Agenda Item # 1 - HOLDOVER SUB-003730-2026

Rogers Group Subdivision

- Subdivision approval to create one (1) legal lot of record from six (6) metes-and-bounds parcels.

APPLICATION NUMBER 1 DATE July 16, 2026

DETAIL SITE PLAN

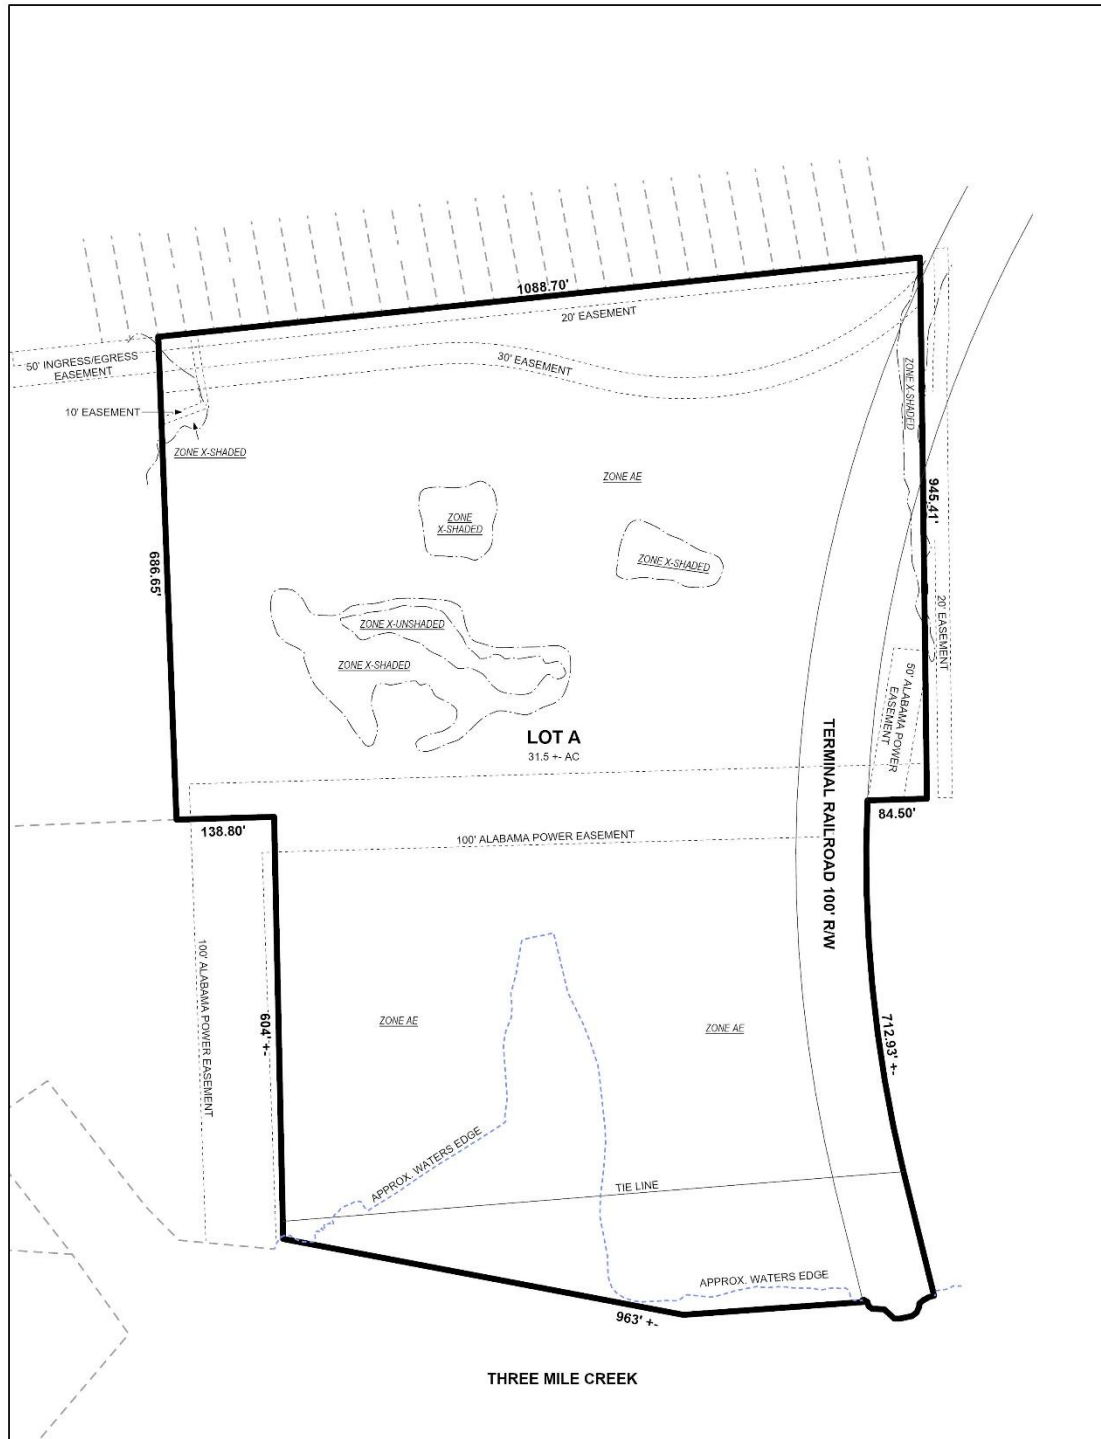
Staff has since received a revised Preliminary Plat that includes only the six (6) parcels zoned I-2, Heavy Industry District.

The Preliminary Plat depicts access to the site via a 50-foot-wide ingress/egress easement located northwest of the property, extending to Bay Bridge Road Cutoff. Section 6.C.4. of the Subdivision Regulations requires all lots to abut a dedicated and maintained public street; however, the easement was established in 1977, with the associated legal instrument referenced on the plat, and appears to have provided access to the property since that time. As such, a waiver of Section 6.C.4. may be appropriate and will be required if the subdivision is approved. If approved, reference to the easement and the associated legal instrument should be retained on the Final Plat.

Additionally, if approved, the Final Plat should be revised to correctly label "Bay Bridge Road Cutoff."

The proposed lot is properly labeled with its area in both square feet and acres, as required by Section 5.A.2.(e).4. of the Subdivision Regulations. If approved, this information should be retained on the Final Plat; alternatively, it may be provided in tabular form.

Pursuant to the Africatown Overlay requirements, a 30-foot-wide buffer is required between industrially utilized property and adjacent residential property in accordance with Article 11.G.1.(a)(1) of the Unified Development Code (UDC). If approved, the Final Plat should illustrate a 30-foot-wide buffer along the northern property line adjacent to residentially zoned property.

The Preliminary Plat depicts an existing 100-foot-wide terminal railroad right-of-way and several utility easements. If approved, these easements and rights-of-way should be retained on the Final Plat. Additionally, the note stating, "No structure shall be constructed or placed within any easement without the permission of the easement holder," should also be retained on the Final Plat.

Finally, the site is located within the Africatown Overlay District. Accordingly, any future development or redevelopment of the property will be subject to the applicable provisions of Article 11 of the UDC. If approved, a note stating as much should be placed on the Final Plat.

1. Retention of the 50-foot-wide ingress/egress easement providing access to Bay Bridge Road Cutoff on the Final Plat, together with reference to the associated legal instrument;

2. Revision of the Final Plat to correctly label "Bay Bridge Cutoff Road";
3. Retention of the lot area in both square feet and acres on the Final Plat, or provision of the same information in tabular form;

4. Illustration of a 30-foot setback along all portions of the site abutting residentially zoned property;
5. Retention of the existing 100-foot-wide Terminal Railroad right-of-way on the Final Plat;

6. Retention of all existing utility easements on the Final Plat;
7. Retention of a note on the Final Plat stating: "No structure shall be constructed or placed within any easement without the permission of the easement holder";

8. Placement of a note on the Final Plat stating that the site is located within the Africatown Overlay District and that development or redevelopment of the site is subject to the applicable provisions of Article 11 of the Unified Development Code;
